CALVERT CLIFFS NUCLEAR POWER PLANT UNIT NO. 1

AMENDMENT TO FACILITY OPERATING LICENSE

Amendment No. 78  
License No. DPR-53

SAFETY EVALUATION BY THE OFFICE OF NUCLEAR REACTOR REGULATION

Figure 3.7-1  
Steam Generator Pressure vs. Auxiliary Feedwater Flow

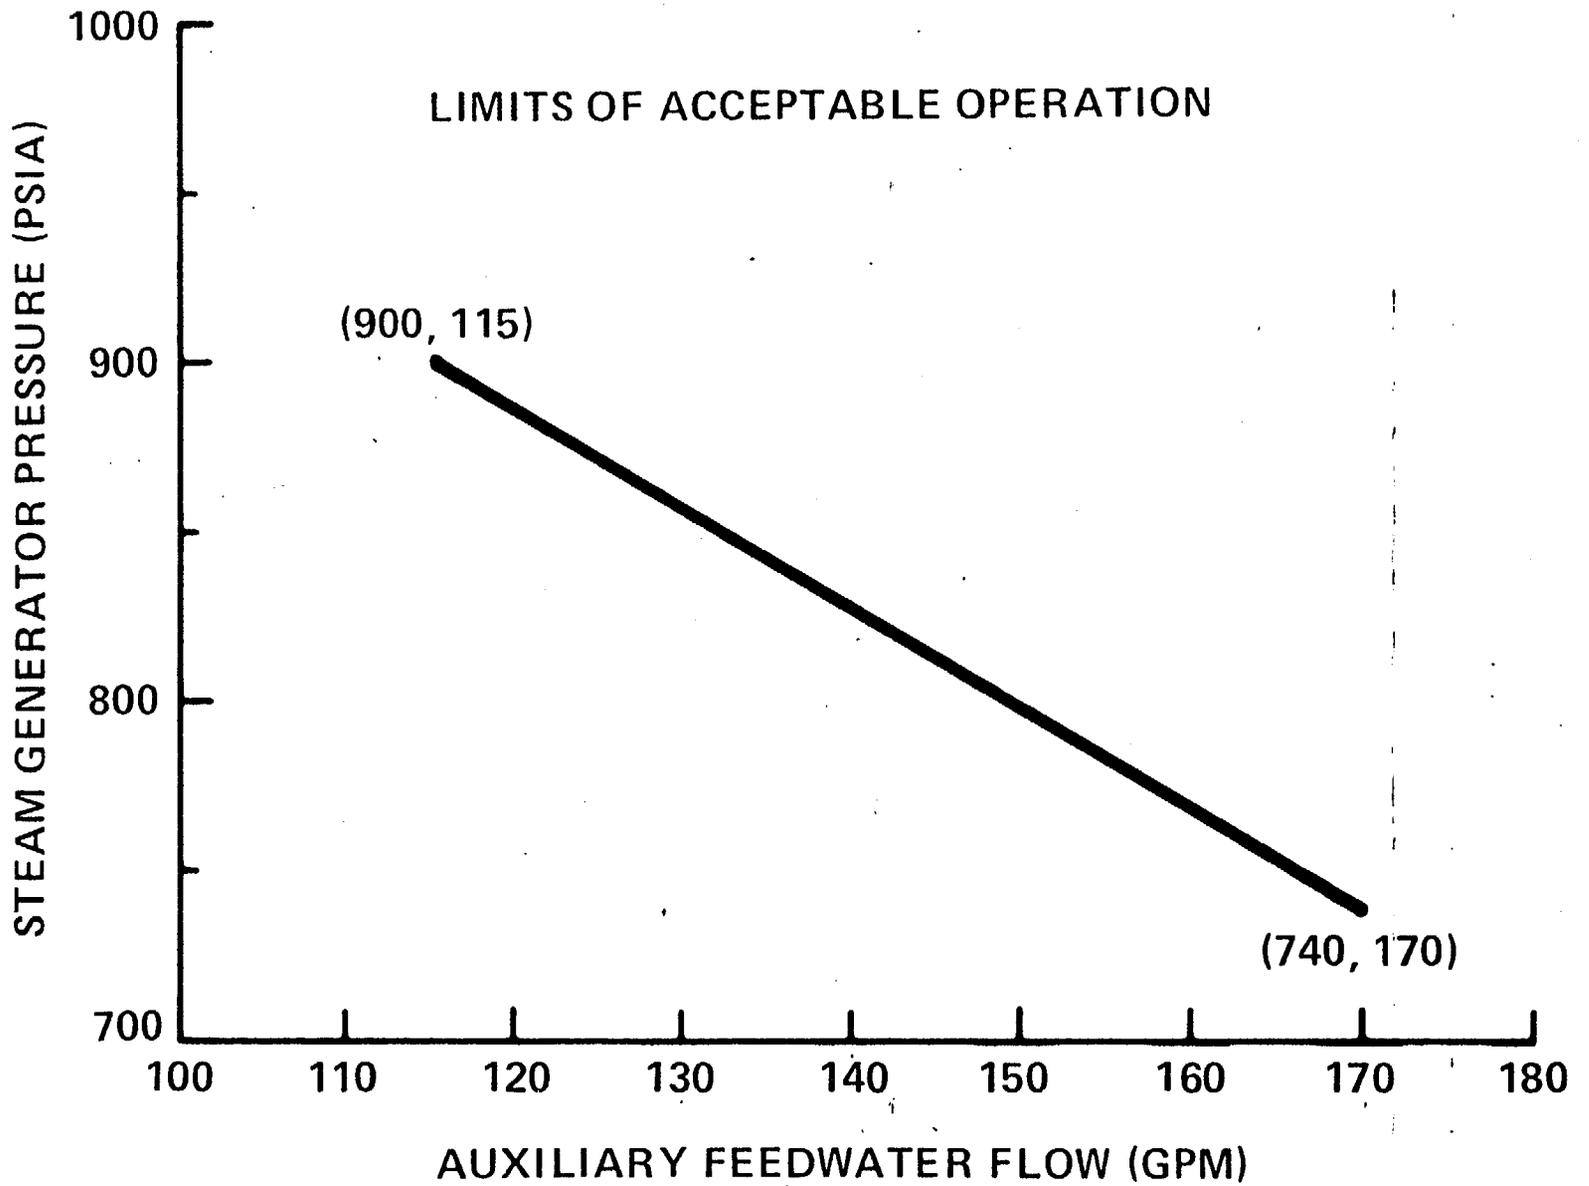
The proposed change to TS Figure 3.7-1, the auxiliary feedwater flow requirement, would provide a pressure dependent range of flows from 115 gpm at 900 psia to 170 gpm at 740 psia. Since steam generator pressure decreases at increasing power levels, the proposed change would allow BG&E to verify adequate auxiliary feedwater flow without returning the steam generator to 900 psia which corresponds to approximately zero power conditions.

flow, within the area of acceptable operation of Figure 3.7-1, to each steam generator." In their August 6, 1982 application, BG&E indicated that the phrase "...area of acceptable operation" implies a two-dimensional "area" shown on Figure 3.7-1. In fact, Figure 3.7-1 contains a one-dimensional relationship; auxiliary feedwater flow is confined between the limits on this line. Accordingly, BG&E has proposed that the word "area" be replaced with the word "limits". We concur with BG&E that the proposed change more closely reflects the meaning of the TS.3.7.1.2 requirements. The change is administrative in nature and has no effect on the safety of the facility.

During the recent refueling outage at Calvert Cliffs Unit 1, BG&E conducted a test to determine the relationship between steam generator pressure and auxiliary feedwater flow\*. The results of the test indicated that for a flow of 115 gpm at 900 psia, the flow increased in a very nearly linear fashion to 170 gpm at 740 psia. This experimentally determined relationship between auxiliary feedwater flow and steam generator pressure is the basis for BG&E's proposed change to TS.3/4.7.1.2. BG&E has shown, analytically, that a flow of 115 gpm (at 900 psia) and a flow of 170 gpm (at 740 psia) are each within a region of values which would allow the reactor operator 20 minutes to either terminate auxiliary feedwater flow or to increase the flow, as needed. The acceptability of this conclusion was the basis for License Amendments 67 and 49. Since there are no additional safety considerations associated with this TS change, we find this change to be within the bounds of previously reviewed safety considerations and therefore, acceptable.

3.7.1.2 At least two steam turbine driven steam generator auxiliary feedwater pumps and associated flow paths shall be OPERABLE and capable of automatically initiating flow, within the limits of acceptable operation of Figure 3.7-1, to each steam generator.

3. Verifying, upon automatic initiation of auxiliary feedwater, a flow within the acceptable operating limits of Figure 3.7-1, Steam Generator Pressure Versus Auxiliary Feedwater Flow.
- \*d. Upon repositioning of 1/2-CV-4511 and/or 1/2-CV-4512 the valve shall be realigned to provide flow consistent with Figure 3.7-1.

A minimum flow of 88 gpm and a maximum flow of 142 gpm to each steam generator when automatically initiating AFW flow for a steam generator pressure of 900 psia is required to ensure sufficient time for operator action to maintain an adequate heat sink for the reactor. A nominal flow setting of 115 gpm at 900 psia is used to account for instrument error and system flow repeatability. Figure 3.7-1 shows the allowable flow as a function of steam generator pressure.
